THM 440-T4 PARKING LOCK AND ACTUATOR SYSTEM CHANGE

CHANGE: Entirely new parking lock and actuator system.

Figure 1

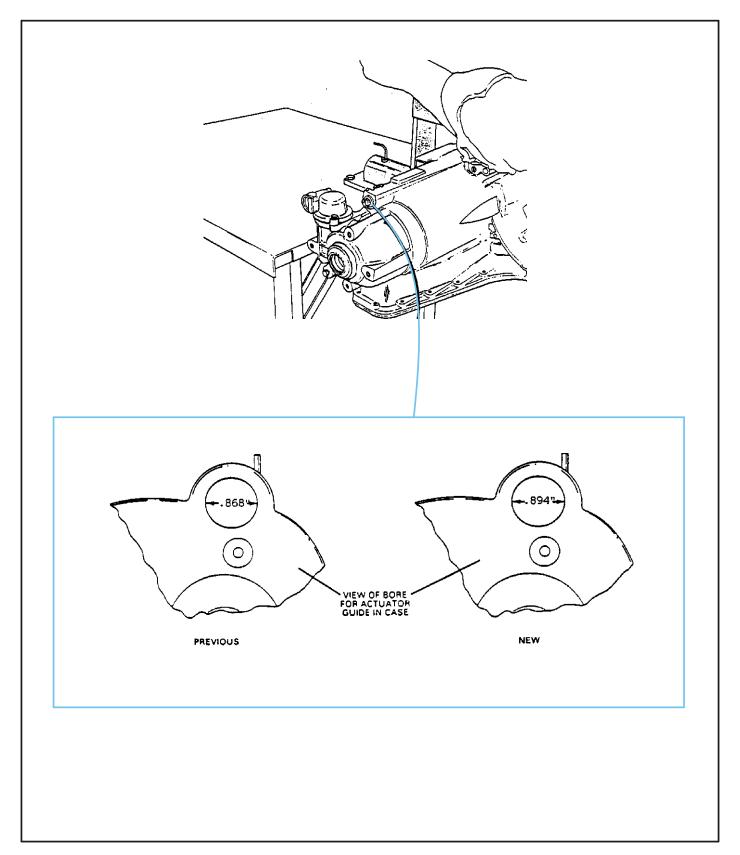
(1)TRANSAXLE CASE- Bore diameter for the actuator guide has been increased by .026", to accommodate the new actuator guide (See Figure 1).

Figure 2

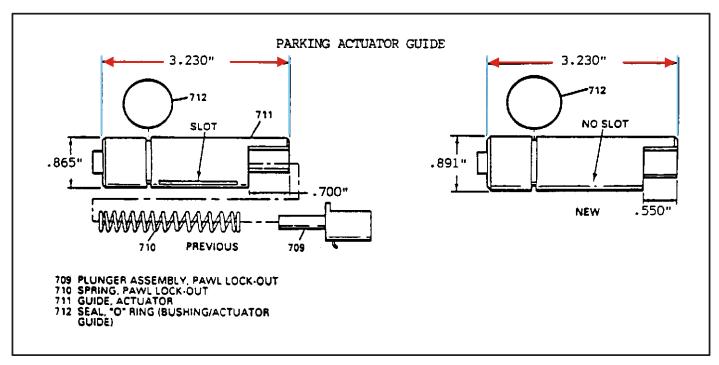
- (2) ACTUATOR GUIDE Outside diameter has been increased by .026" for the increased diameter of the bullet on the parking rod. The plunger assembly and spring have been eliminated. The slot in the actuator guide has been eliminated (See Figure 2).
- (3) ACTUATOR GUIDE "0" RING The "0" ring is now larger diameter to seal larger diameter actuator guide (See Figure 2).
- (4) PARKING ACTUATOR ROD The "Bullet" on the park rod is now .070" larger in diameter, and the length increased by .543" (See Figure 3).
- (5) PARKING PAWL The parking paw1 lock-out pin has been eliminated, and the dimension (Width) of the parking paw1 was reduced by .039" (See Figure 4).
